Descriptive Report to Accompany Hydrographic Survey H11901

Project OPR-P184-RA-08

Pavlof Island, AK

Revisions and Corrections During Office Processing and Certification

Figure 2: H11901 Contemporary Bathymetry Junction Surveys, chart 16549.

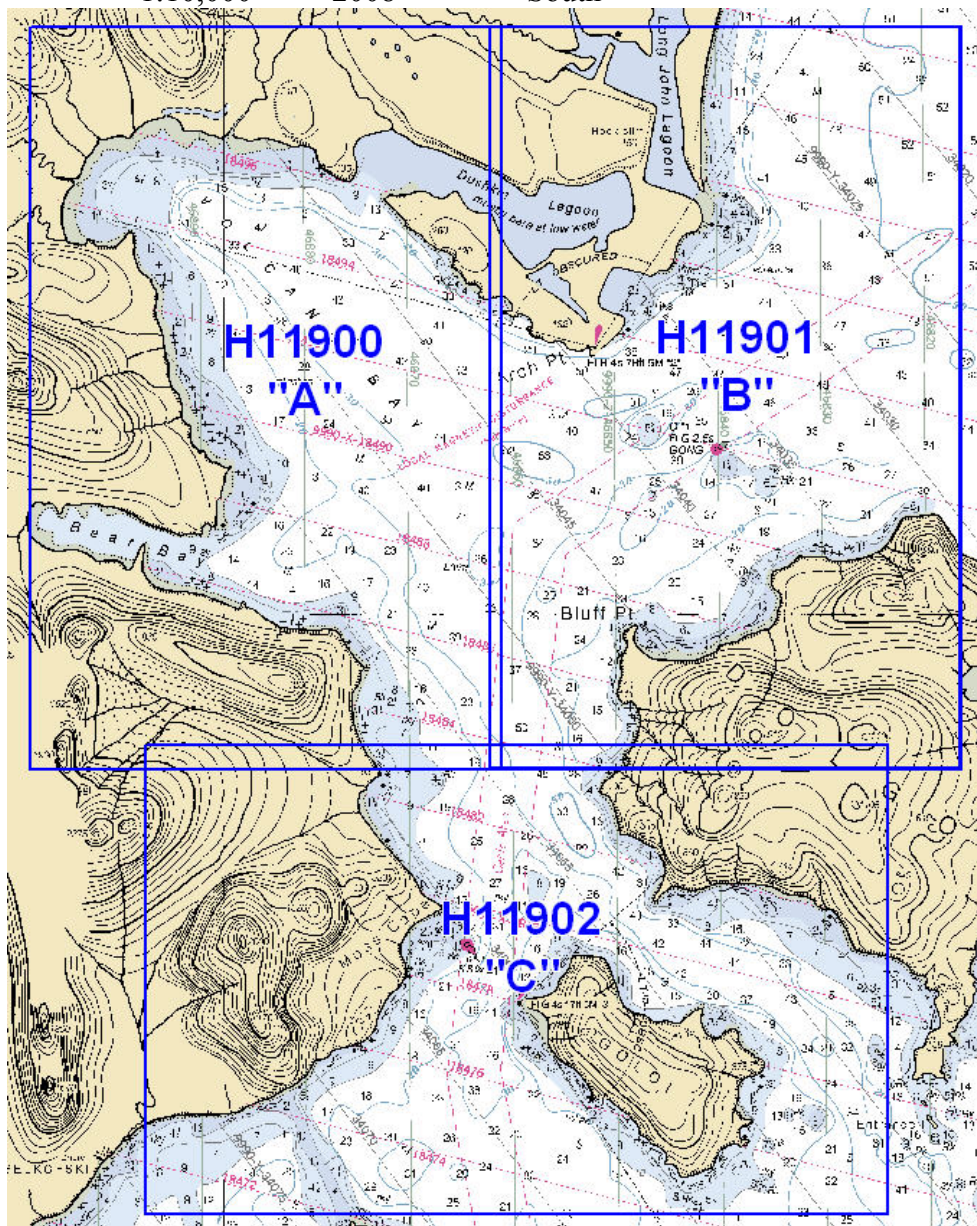
The following contemporary bathymetric surveys junction with H11901³ (See Figure 1):

A comparison between H11901 and its two contemporary bathymetric surveys. H11900 and H11902 (figure 2) revealed excellent agreement in all common areas with no significant offsets.⁴ The comparison was made in Caris subset mode; no differences greater than 0.3m were observed.

³ H11901 junctions with survey H11900 to the west which as already been compiled, a common junction was made with this survey. H11901 also junctions with surveys H11902 to the south, H12076 to the north-east, and H12079 to the south-east which have not been compiled. A common junction was made to the south for the junction to H11902, though a common junction was not made on the east side so the eastern extent of H11901 should supersede H12076 and H12079 in the common areas.

Figure 8: 15 fathom sounding near charted 24 fathom depth (chart 16549).

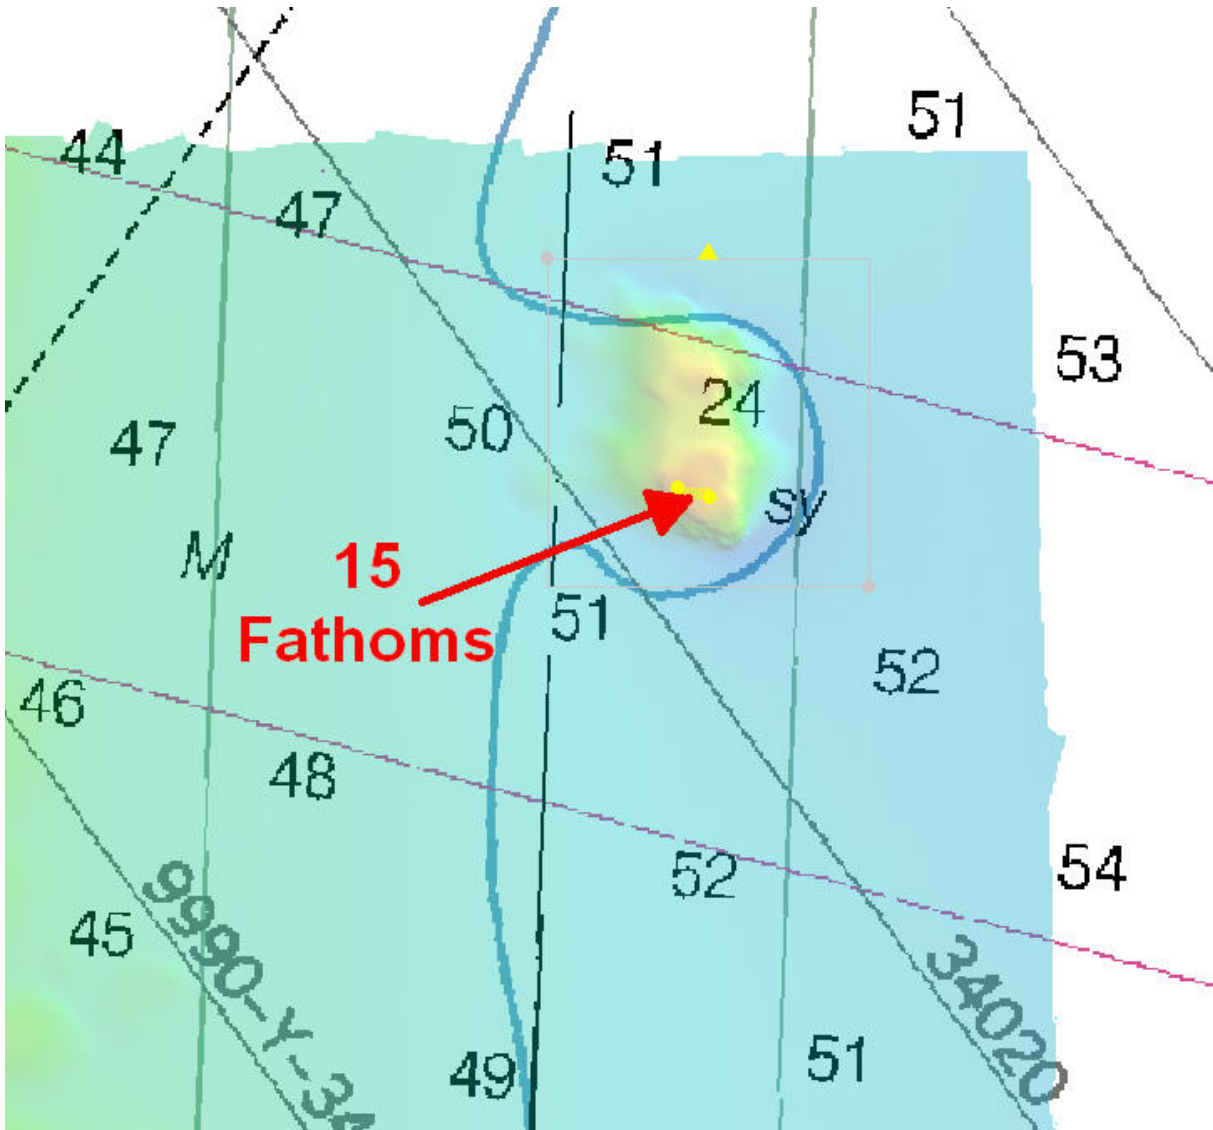
A 15 fathom sounding was acquired in a shoal area approximately 250 meters south of a charted 24 fathom depth at the northeast corner of the survey (Figure 8). Surrounded by 50 fathom depths, this shoal area is not very well represented as currently charted.⁸

⁸ Concur, a 15 fathom sounding has been selected for charting at 55-14-42.9N, 161-49-37.8W.

Figure 9: 28.5 fathom sounding (chart 16549).

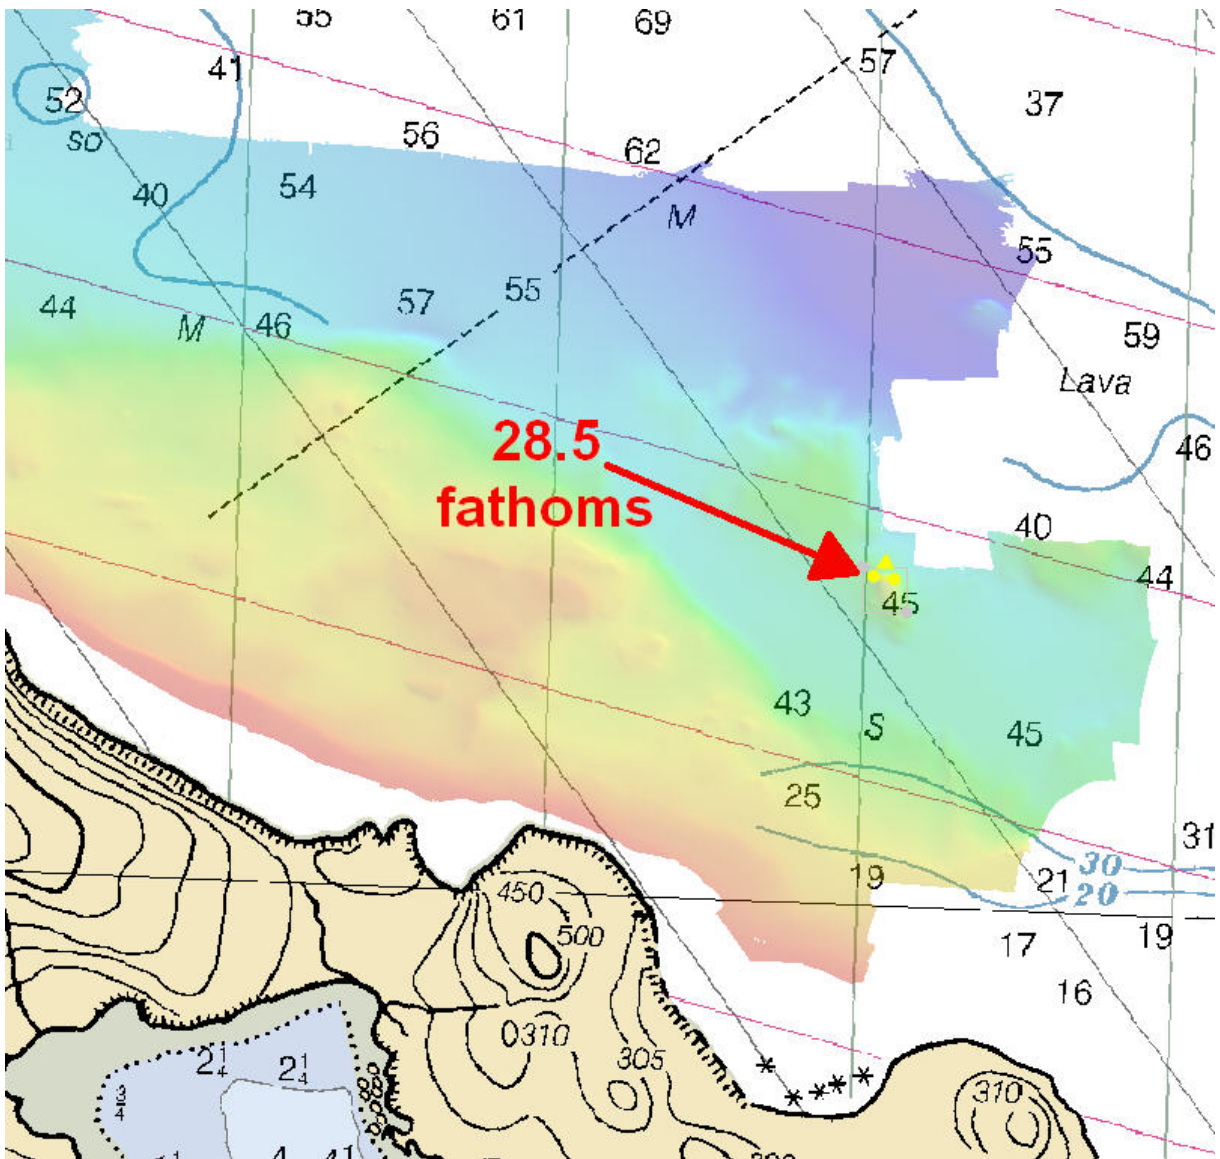
A 28.5 fathom sounding was acquired approximately 160 meters northwest of a charted 45 fathom depth near the eastern extent of the expanded survey area for H11901.⁹ Depths are sparse in this area of chart 16549(Figure 9).¹⁰

⁹ A 28 fathom sounding has been selected for charting at 55-10-56.0N, 161-44-25.8W.

¹⁰ Soundings have been selected for this previously un-surveyed region at a density that emulates the sounding distribution of the rest of chart 16549.

Figure 11: 3.3 Fathom least depth over charted $1\frac{3}{4}$ fathom depth (chart 16549).

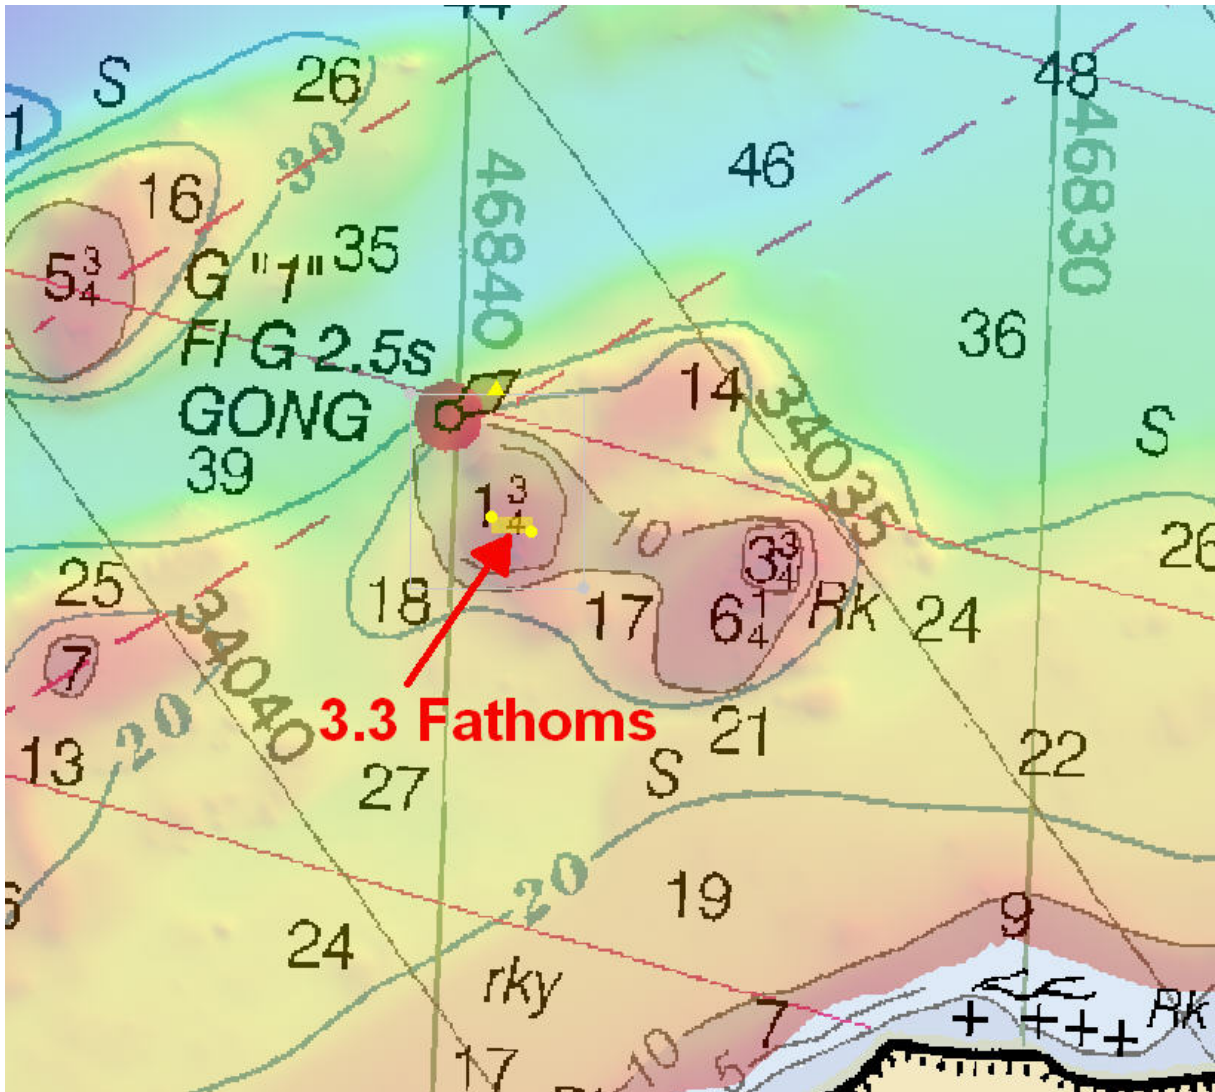
Complete multibeam coverage was achieved over the charted $1\frac{3}{4}$ fathom depth approximately 300 meters southeast of the G "1" buoy; the least depth detected was 3.3 fathoms (figure 11).¹²

¹² A 3 fathom rock has been selected for charting at 55-11-15.7N, 161-52-16.8W.

Figure 12: General area of deeper than charted (chart 16549).

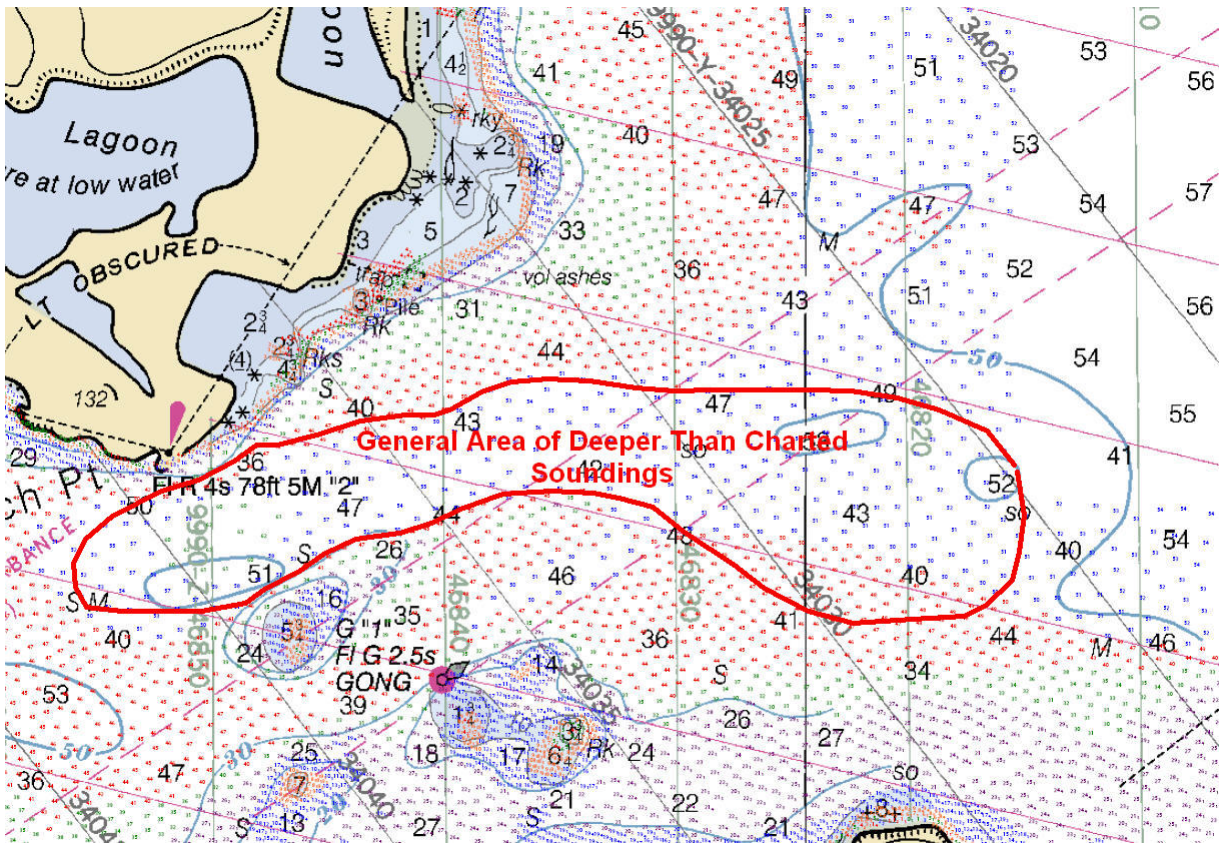
Compared with chart 16549, H11901 survey data revealed a general deepening trend in the area east southeast of Arch Point (figure 12). The Hydrographer recommends charting as per digital data.¹³

¹³ Concur.

Figure 13: No evidence of charted dangerous underwater rocks (chart 16549).

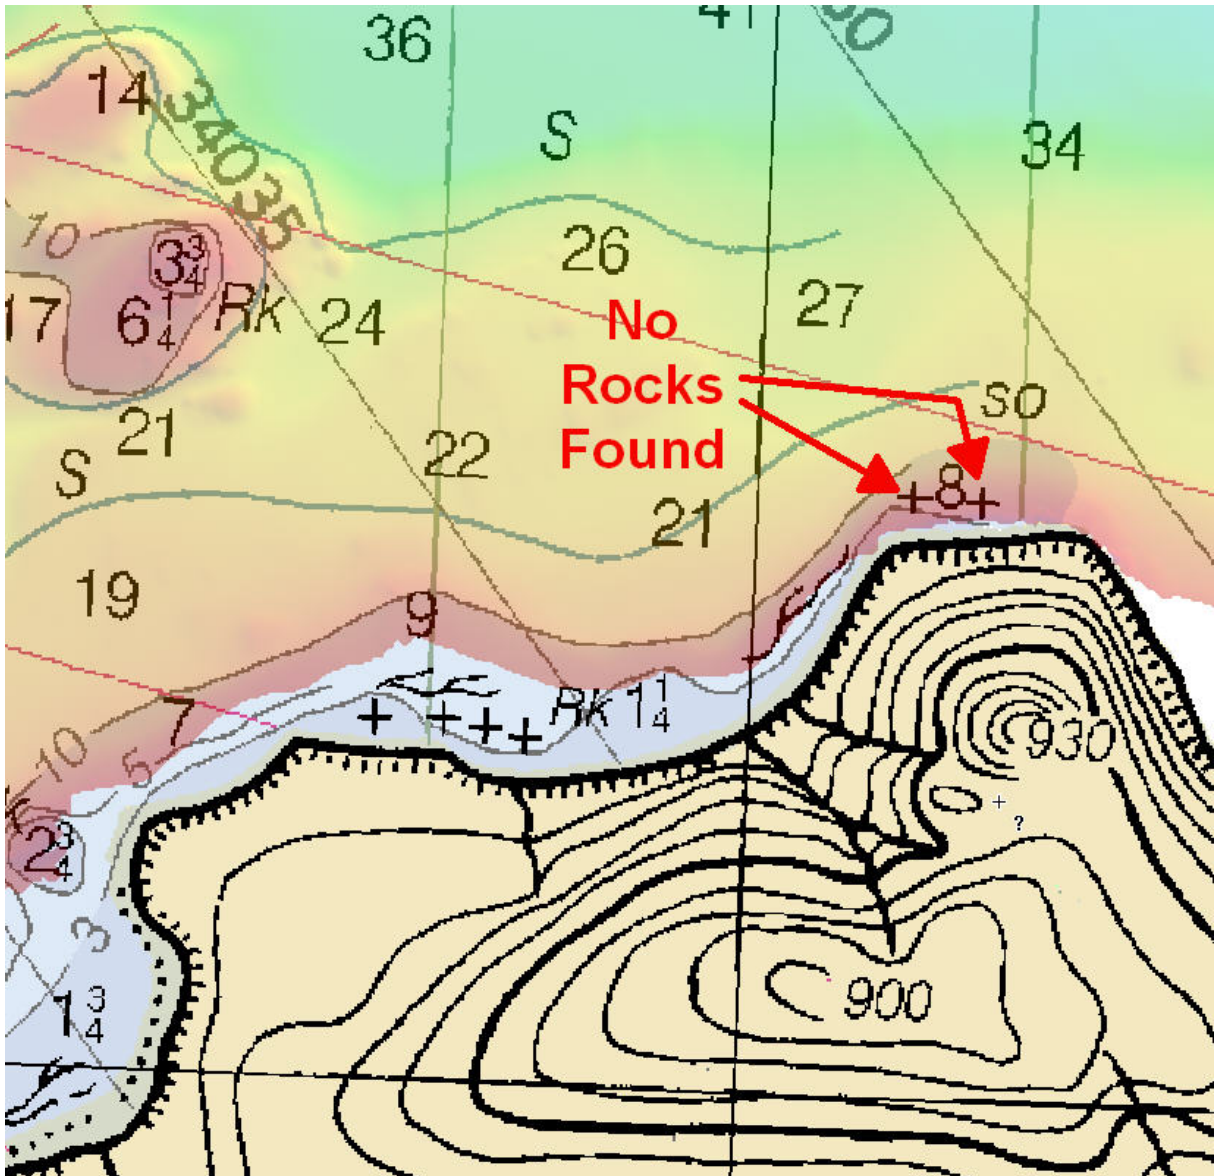
Complete multibeam coverage was achieved over a pair of charted dangerous underwater rocks off a northern point of Dolgoi Island; no evidence of either rock was found (figure 13).¹⁴

¹⁴ Blue notes have been created recommending the removal of these two rocks.

Figure 14: Charted (16549) Islet Not Found.

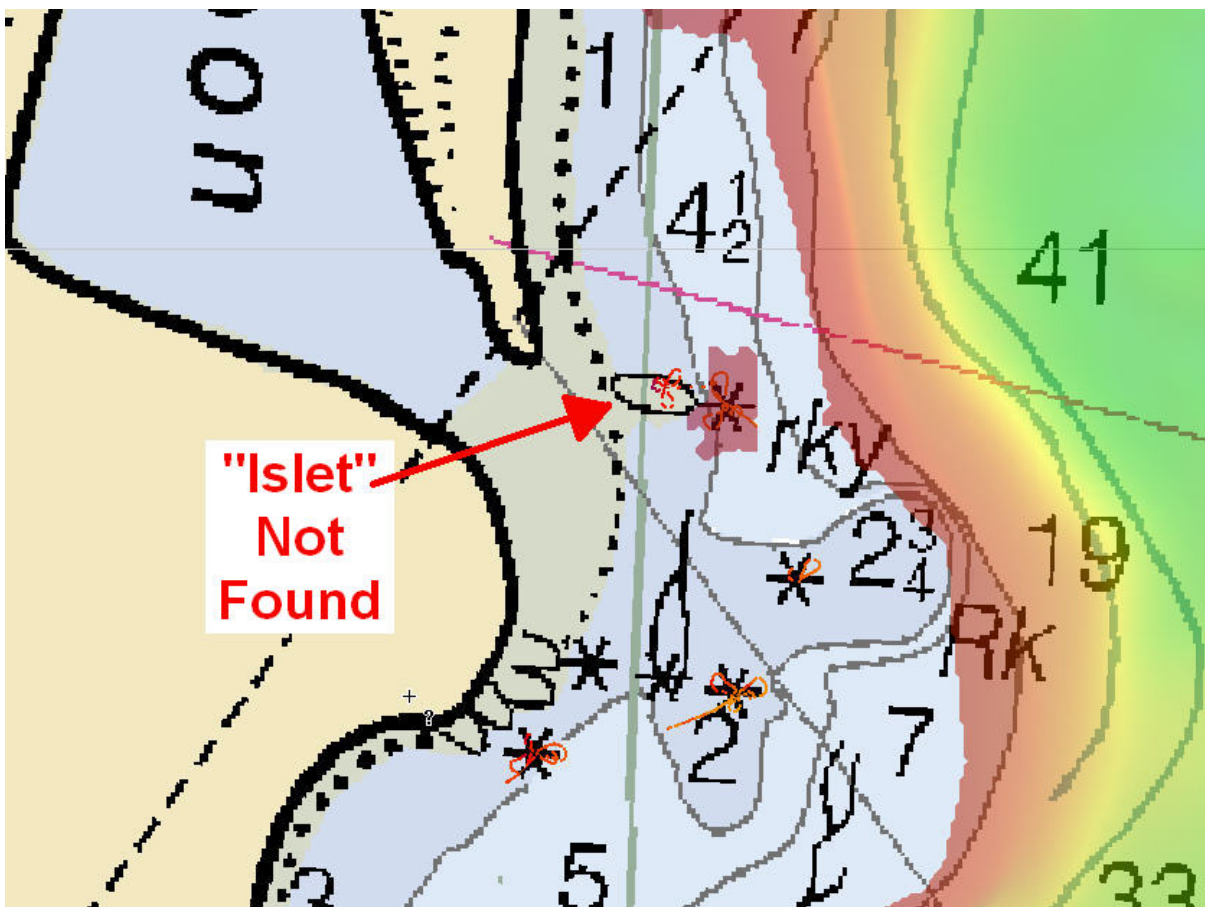
During investigation of AWOIS item 53691, a Maritime Boundary Claim that identified "...a charted islet in the vicinity of Long John Lagoon," no such islet was found (figure 14). The charted (16549) feature in question is depicted with a solid line, indicative of dry land although it is shaded as an area that covers and uncovers. A small reef-like feature inshore of the charted "islet" was located; for more information refer to the survey feature report in Appendix II and AWOIS item 53691.¹⁵

¹⁵ AWOIS report is appended to this report.

Figure 15: Shoal area, No “Rk” detected.

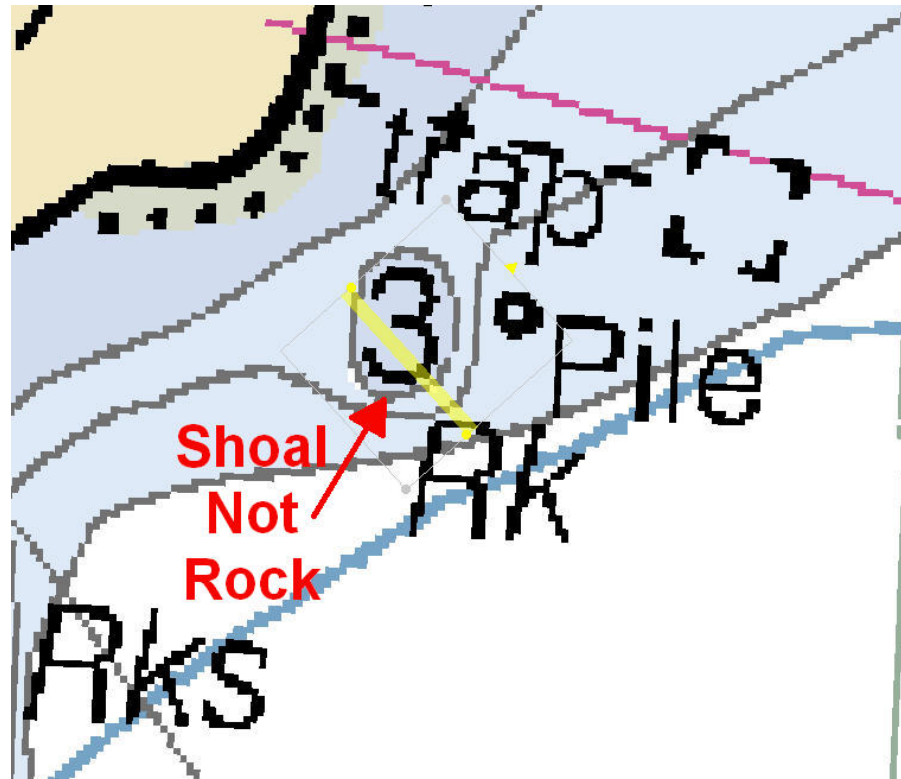
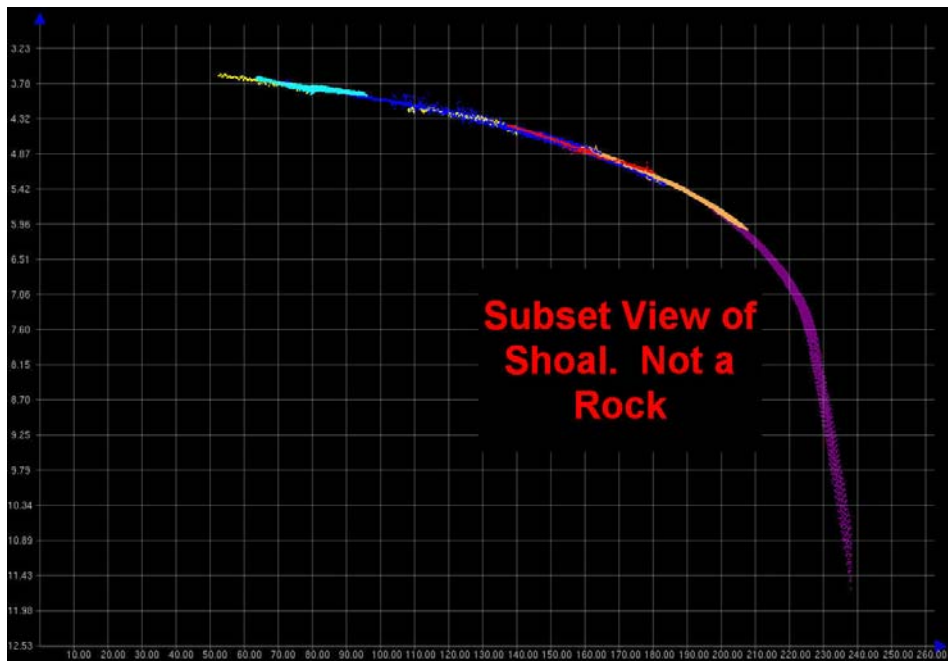
A charted (16549) three (3) fathom rock (figure 15) between Arch Pt and Long John Lagoon was found to actually be a shoal area; no rock was detected (figure 16). The hydrographer recommends deleting “Rk” from the chart where it relates to this shoal.¹⁶

¹⁶ Concur with clarification, a 3 fathom 2 foot sounding has been selected for charting at 55-12-55.3N, 161-53-05.7W.
